Airport Land Use Commission

January 30, 2017

**RE: ALUC Consistency determination for a Commercial office building,
located within the Peery Park Specific Plan area at 675 Almanor Avenue.**

675 Almanor

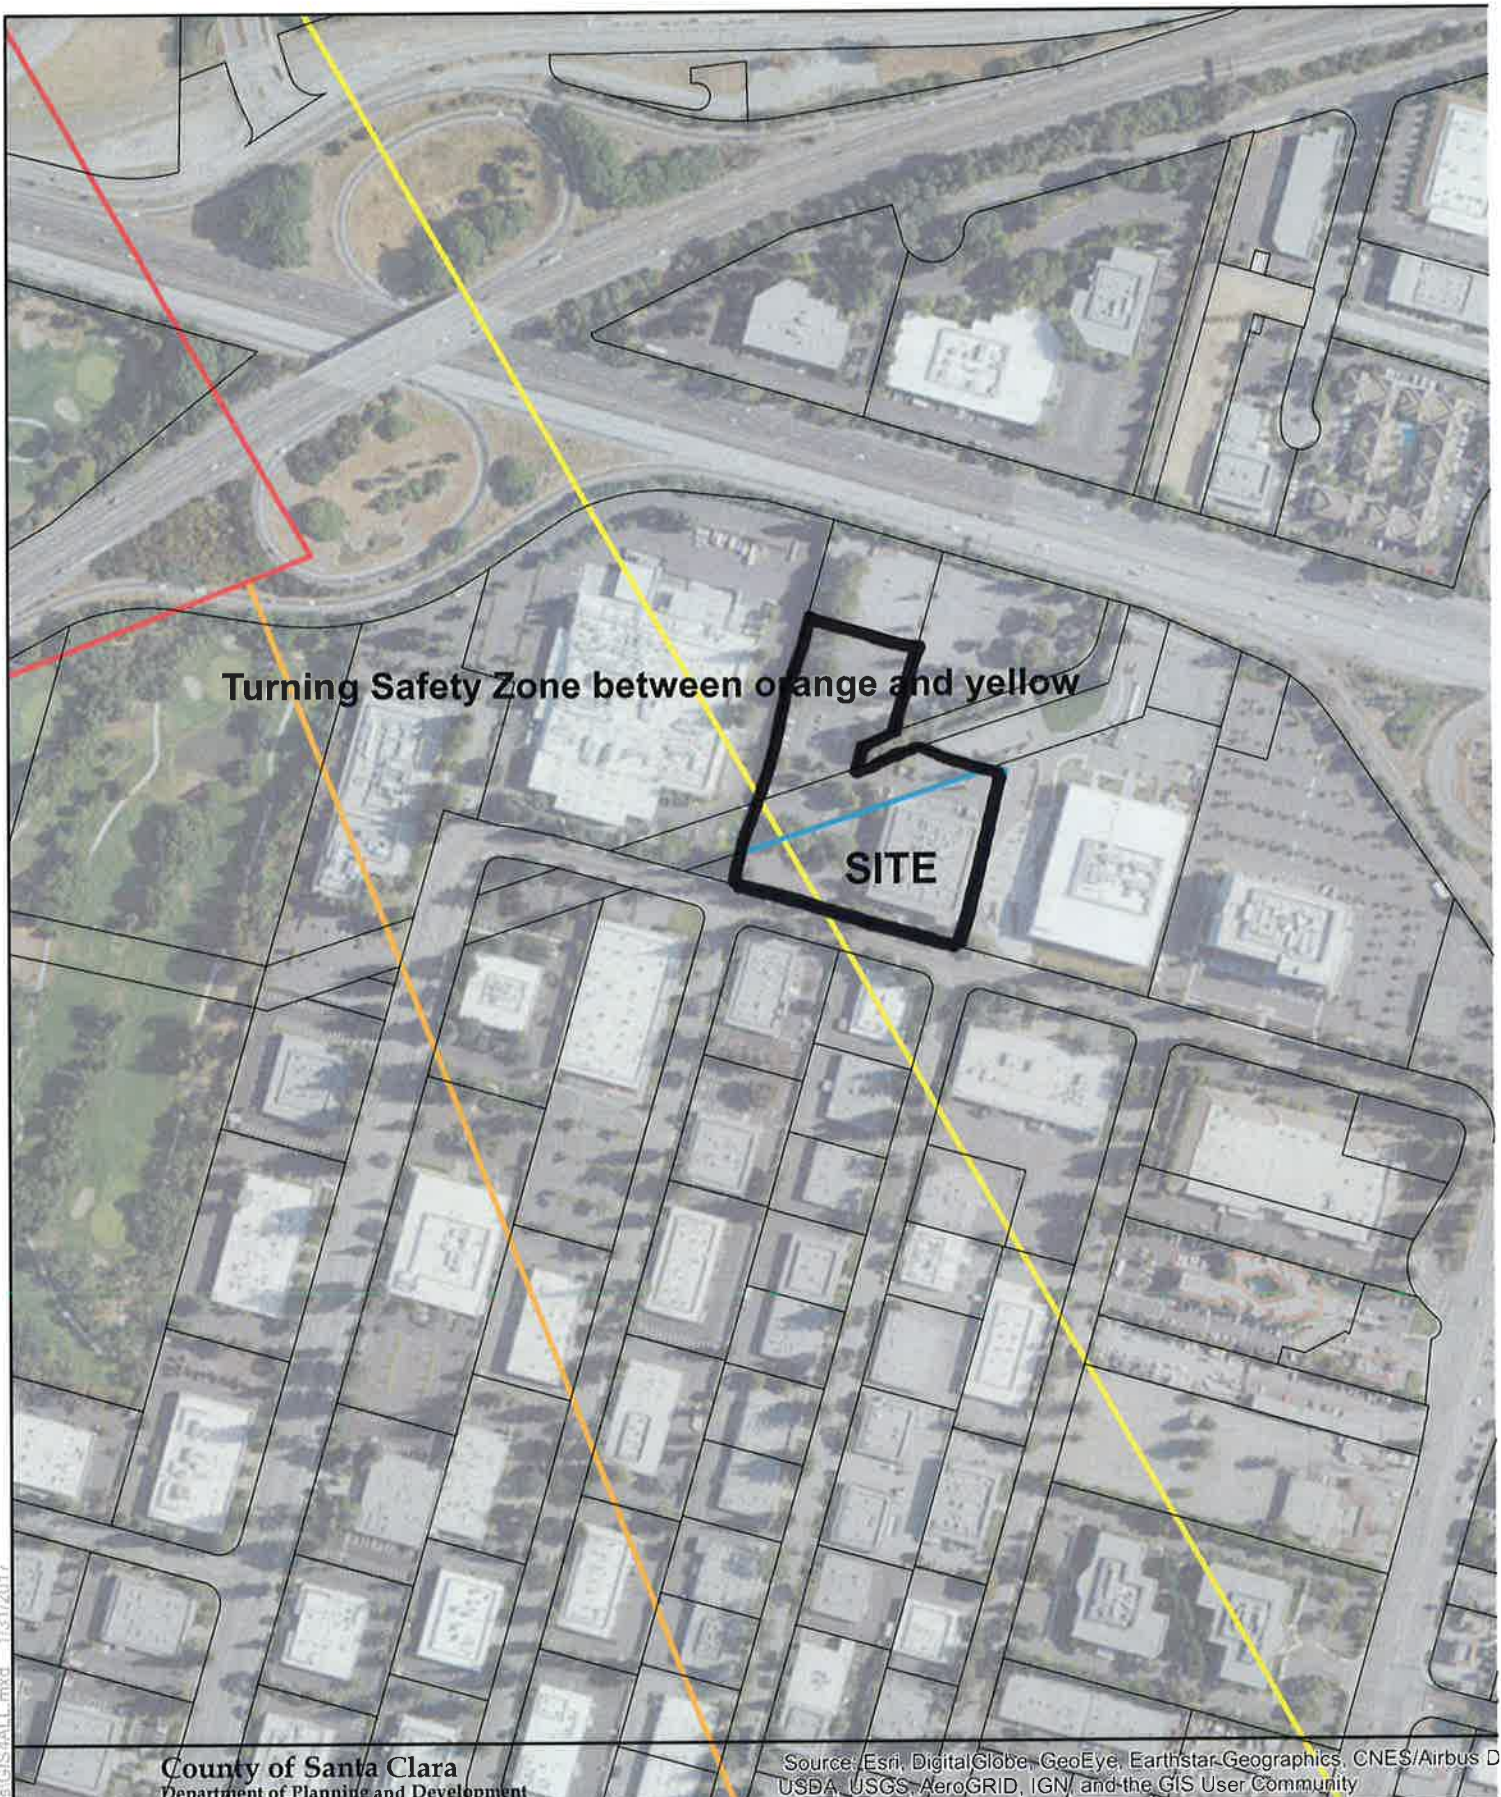
The project site is located within the Airport Influence Area (AIA) of Moffett Federal Airfield. The site is located outside of all noise contours, but is located partially within the southwesterly Turning Safety Zone (TSZ). Also, structures are proposed approximately beneath the 182 Mean Sea Level (MSL) FAA Part 77 Surface, which is used by the ALUC as a height restriction boundary.

The project has been designed to avoid any structures within the TSZ and has parking and landscaping proposed within this area.
